SAFETY RECALL

Brake Fluid Flush Voluntary Safety Recall Campaign

Reference: R1814

Date: December 20, 2018

BRAKE FLUID

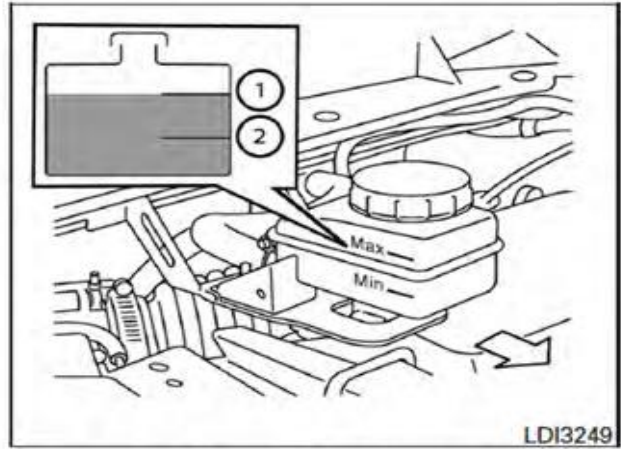
Check the fluid level in the reservoir. If the fluid is below the MIN line② or the brake warning light comes on, add Genuine NISSAN brake fluid CLARIANT 6M DOT4 or equivalent DOT4 up to the MAX line①. If the fluid must be added frequently, the system should be checked by a NISSAN dealer.
